RE:, Pond-Drain Pipes, United Blood Services

DRAINAGE REPORT

RE: Drainage Study for United Blood Services

United Blood Services Comments JIS-D9; B. Burnett

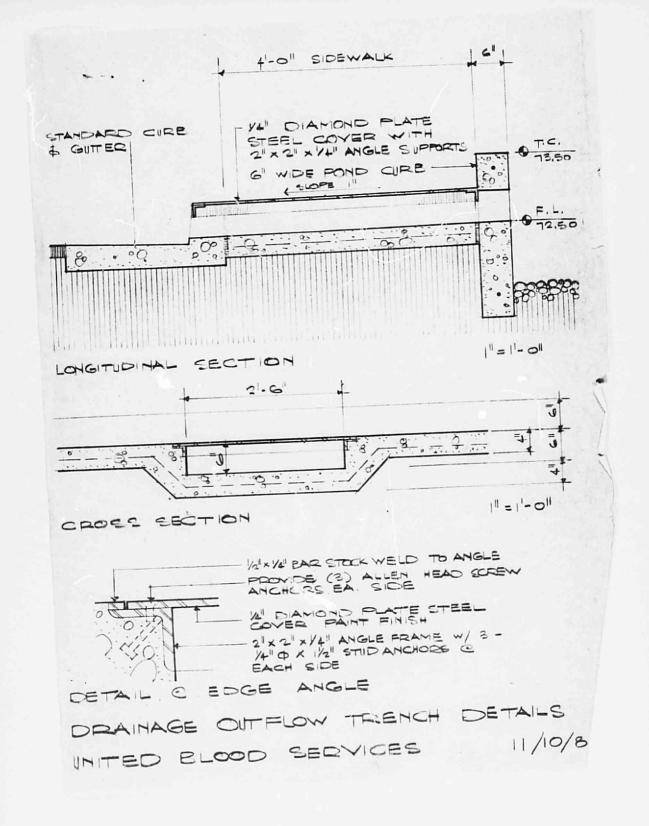
Per your request please find the enclosed drawings depicting a slight modification in the drainage plan on the above referenced project.

Because of a misinterpretation of existing grade conditions, to maintain the correct elevations on the outflow from pond "C" we need to get under the sidewalk. The drawings detail where and how this will occur.
